Request for Approval of Alternative Waste Management Practices

Well Operator Brooks Whilton		DEP ID 48081	Well Permit or Registration Number 123-49322	
Address 1695 East Fifth Avenue			Well Farm Name Wolfe	
City Warren	State pa	Zip Code 16365	Well # 124	Serial #
Phone 814-723-3706	Fax	County Warren	Municipality Mead Township

Well 124
on the
The Wolfe Lease
Whilton Oil

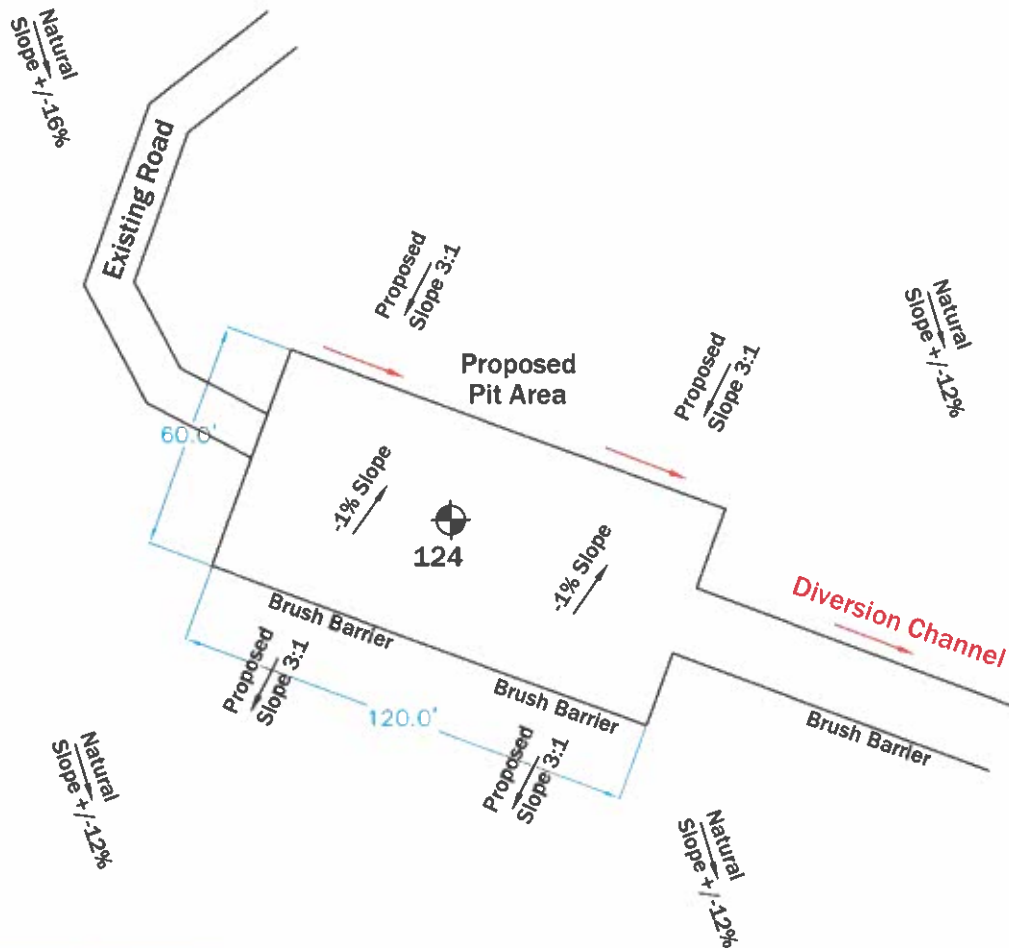
Brooks Whilton is requesting DEP approval for disposal of uncontaminated drill cuttings into a structurally sound and unlined drill pit.

Before the drill cuttings enter the pit, fresh water will be injected into the blooie line, eliminating dust. The pit will be located more than 100' from a stream or wetland and 200' from an existing building or water supply. The Farnsworth Branch lies +1025' south east of the clearing limits, there aren't any wetlands and buildings within 400' of the project.

The attached site plan depict well and pit location (depending upon soils, drainage and other conditions observed during construction) and any stream, wetland or building that may be within 250' of the well.

Prior to fracing, a 20 mil liner will be installed in the pit, on top of the drill cuttings, to contain frac fluids.

DEP USE ONLY		
☒ Approved ☐ Denied DEP Representative: Brian Ayers	Conditions: ☒ YES, see below or attached. ☐ NO	Date 06.04.26
Conditions: Please adhere to the attached special conditions.

1. Notify their local Oil and Gas Inspector three days prior to dusting.
2. Drill cuttings shall remain on the well site they are generated and shall not be dispersed off-site via air, surface water, or groundwater.
3. All isolation distances identified in 25 Pa. Code § §78.60 – 78.63 are applicable.
4. Drill cuttings may be disposed of in a pit, without contact with season high ground water.
5. Upon well completion, the pit shall be backfilled and graded to promote runoff. The stability of the backfilled pit shall be compatible with surrounding area and the pit area shall be revegetated to stabilize surface soil.
6. Land application may only occur on the cleared well pad area and the drill cuttings shall be spread and incorporated to a depth of at least 6 inches and revegetated to stabilize surface soil.
7. No land application shall occur if the ground is frozen or saturated.
